## Technical Memorandum

**SUBJECT:** Review of Wellborn SUD Lightsey Property Well Simsboro Aquifer Evaluation Report

**DATE:** September 1, 2023

Figure 4 Simulated Additional Drawdown in the Simsboro Formation after 1 Year  
WELLBORN SUD  
PROPOSED LIGHTSEY PROPERTY SIMSBORO WELL

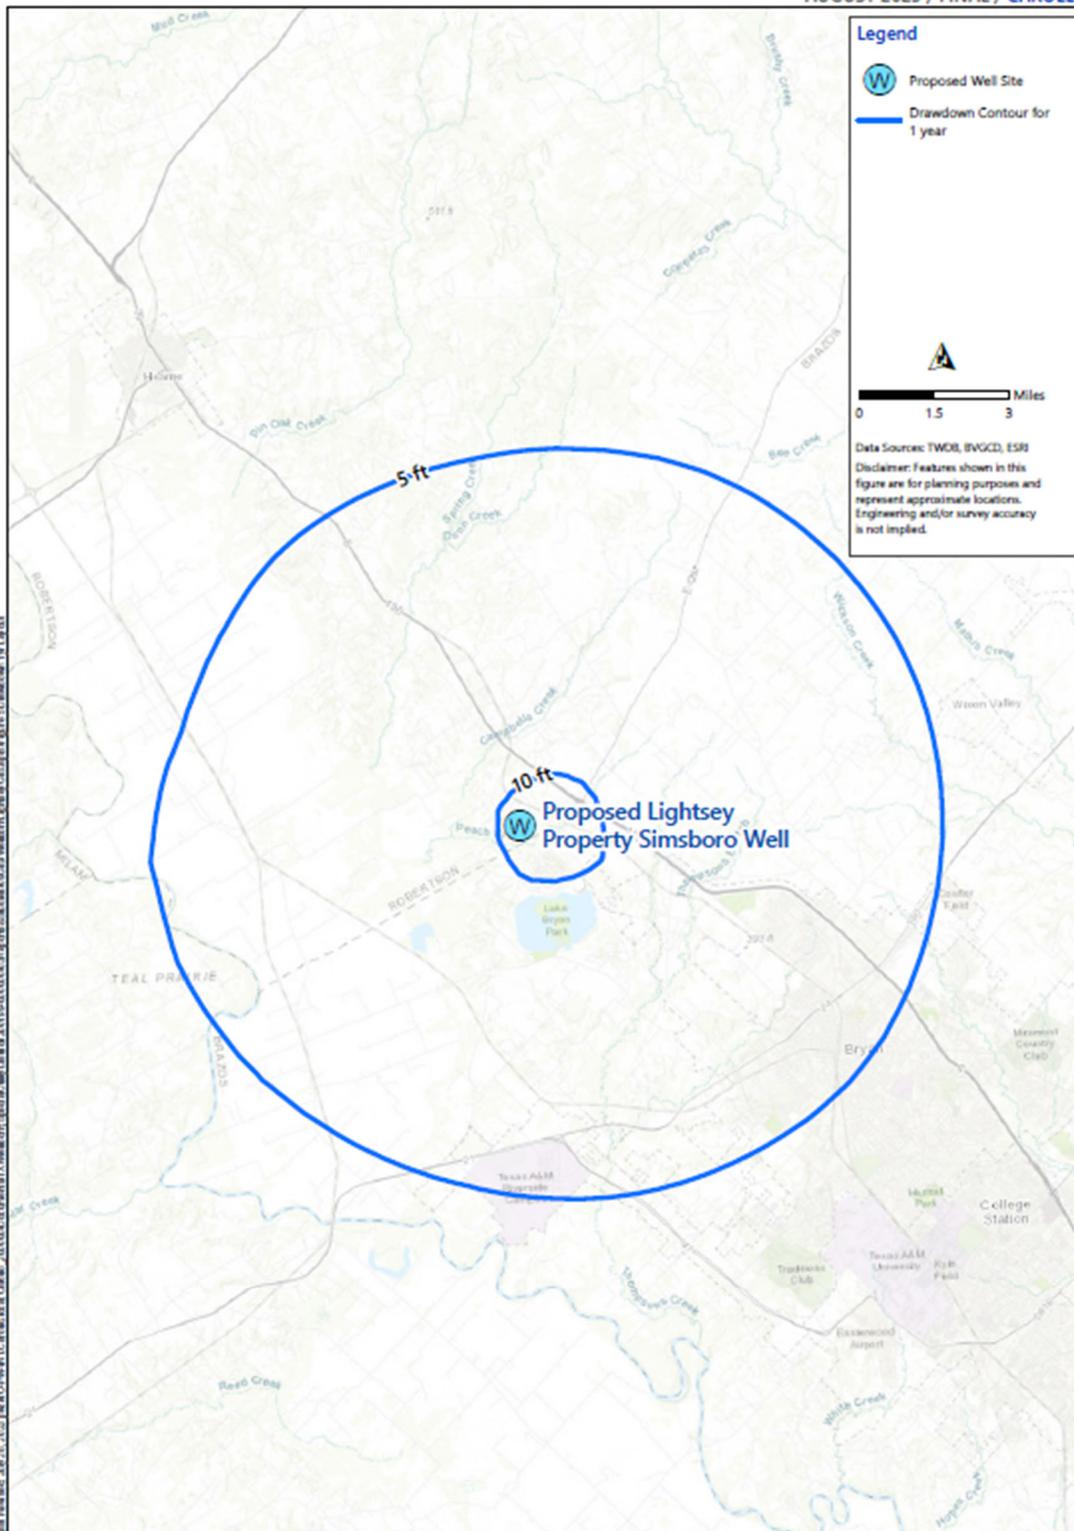
A copy of the Carollo 1-year and 10-year GAM simulated interference drawdown illustrations from the AER (Carollo Figures 4 and 5) are attached to this memorandum. Table 3 in the AER shows GAM simulated 1-year and 10-year drawdown estimates at Wellborn SUD Well 7 (BVDO-0285) and the City of Bryan Well 18 (BVDO-0003), which are the only BVGCD permitted and registered Simsboro wells within 1-mile of the proposed well.

AGS performed GAM simulations to verify the Carollo GAM simulations and results show drawdown estimates that are consistent with results presented in the AER. AGS was able to replicate the drawdowns at distance after 1-year of pumping (about 7 and 8 of drawdown at 5 miles and about 8 to 10 feet of drawdown at 1 mile) and 10-years of pumping (about 8 to 9 feet drawdown at 5 miles and about 11 to 14 feet of drawdown at 1 mile).

The GAM estimated drawdown contours at distance appear to be influenced by faults included in the GAM, which are in the same general area as faults that have been mapped by GWC and AGS using local geophysical logs and other hydrogeologic data.
